Solver[™]
BULLETIN

BULLETIN: 25886

Upper Ball Joint Premature Failure

Dodge Dakota and Durango

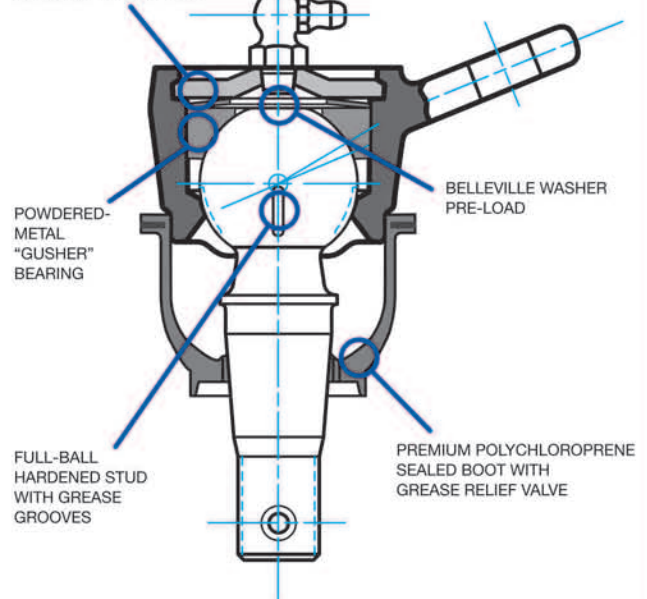
Premature Failure / Excessive Play / Joint Separation

- Non-serviceable socket design is unable to flush contamination leaking past cover plate into the socket assembly; corrosion and wear quickly set in.
- Boot failure can cause lubrication loss, and the bearing quickly wears causing excessive deflection, loose steering, alignment angle changes and possible ball joint separation.

CORRODED COVER PLATE FROM INTRUSION LEAKING INTO SOCKET

CORROSION IN HOUSING INDICATING INTRUSION

WORN, FAILED BEARING

CARQUEST® K7392

- Serviceable CARQUEST® Chassis socket design features premium polychloroprene sealed boot technology, with a special grease relief valve that prevents contamination.
- Greaseable Design.
- Belleville washer pre-load provides lower torque and stud articulation with minimal axial clearance.
- CARQUEST® Chassis' patented cover plate seats in a radial fashion against the housing, creating a sealed environment and keeping contamination out.
- Hardened, powdered-metal bearings are not prone to excessive wear often experienced by plastic bearings under adverse conditions.

PATENTED COVER PLATE
